Proposal for editorial correction to ECE/TRANS/WP.29/GRE/42

(Collective amendments to Regulations Nos. 3, 6, 7, 48, 77 and 91)

GRE-68-02 Corr.2 (This document) contains editorial corrections following a review with the GRE secretariat to ensure that the proposal is in line with the latest state of the regulations including amendments submitted for WP29-158. These are also identified in the comments added to the right-hand column.

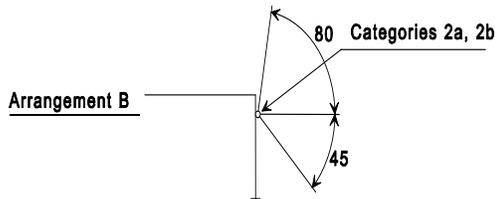
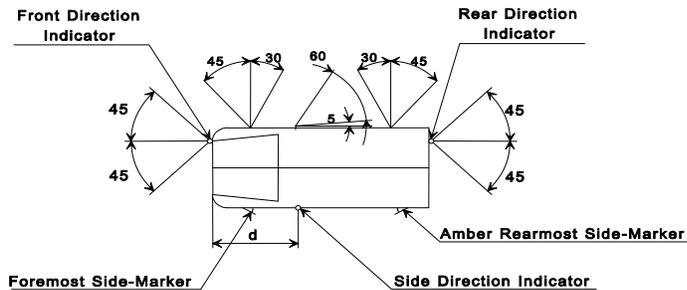
~~For M1 and N1 category vehicles, the value of 45° inward for the direction indicator lamps of categories 1, 1a or 1b, whose lower edge of the apparent surface is less than 750 mm above the ground, may be reduced to 20° under the horizontal plane containing the reference axis of this lamp.~~

For the direction indicator lamps of categories 1, 1a, or 1b, 2a and 2b mounted below 750 mm (measured according to the provisions of paragraph 5.8.1), the inward angle of 45° may be reduced to 20° under the H plane.

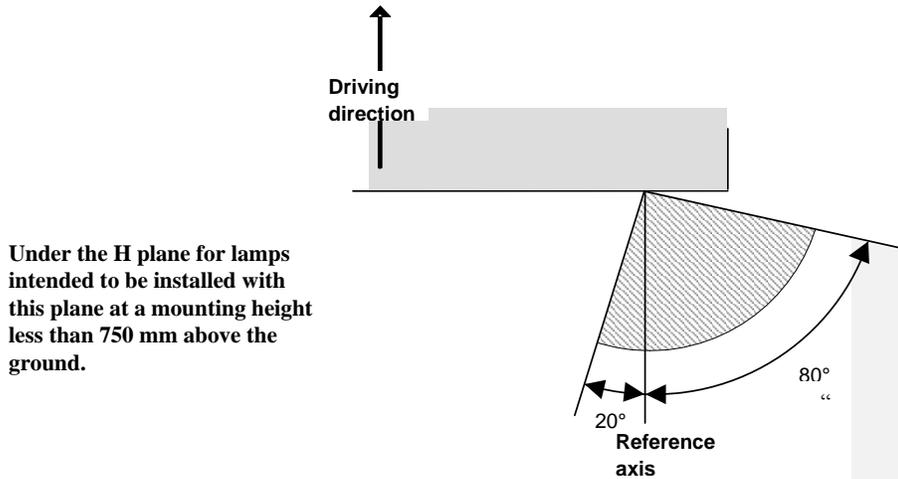
Comment [G.R.D9]:
This is the correction of the text shown in GRE/2012/42

During the preparation of this proposed collective amendment the replacement of the wording "reference axis" by "H-Plane" was erroneously omitted in the proposal C.

Add a new diagram and associated text, to read:

Under the H plane for lamps intended to be installed with this plane at a mounting height less than 750 mm above the ground.

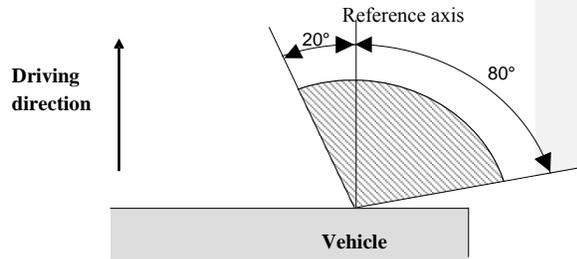
~~Front position lamps.
End-outline marker lamps~~

~~On and above the H plane for all lamps.
Under the H plane for lamps intended for M2, M3, N2 or N3 category vehicles.~~

~~Front position lamps.
Under the H plane for M1 or N1 category vehicles.~~

Comment [G.R.D11]:
Delete the words "End-outline marker lamps"
This was an error when drafting this proposal

Under the H plane for front position lamps intended to be installed with this plane at a mounting height less than 750mm above ground.

Rear position lamps,
end-outline marker lamps

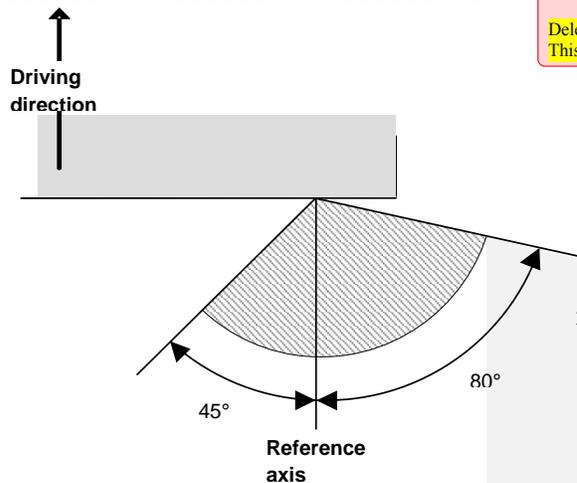
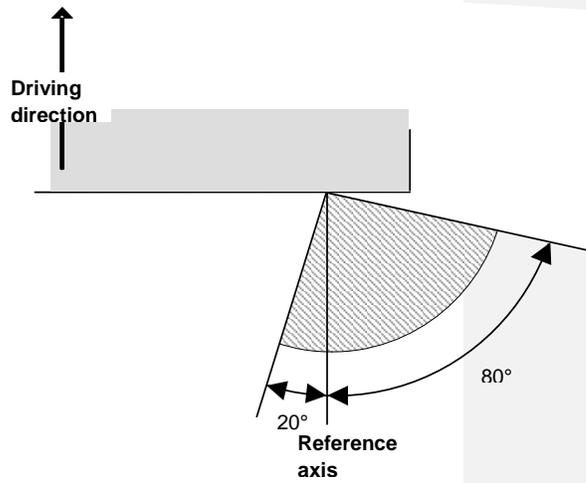
Comment [G.R.D12]:
Delete the words "End-outline marker lamps"
This was an error when drafting this proposal

Under the H plane for rear position lamps intended to be installed with this plane at a mounting height less than 750mm above ground.
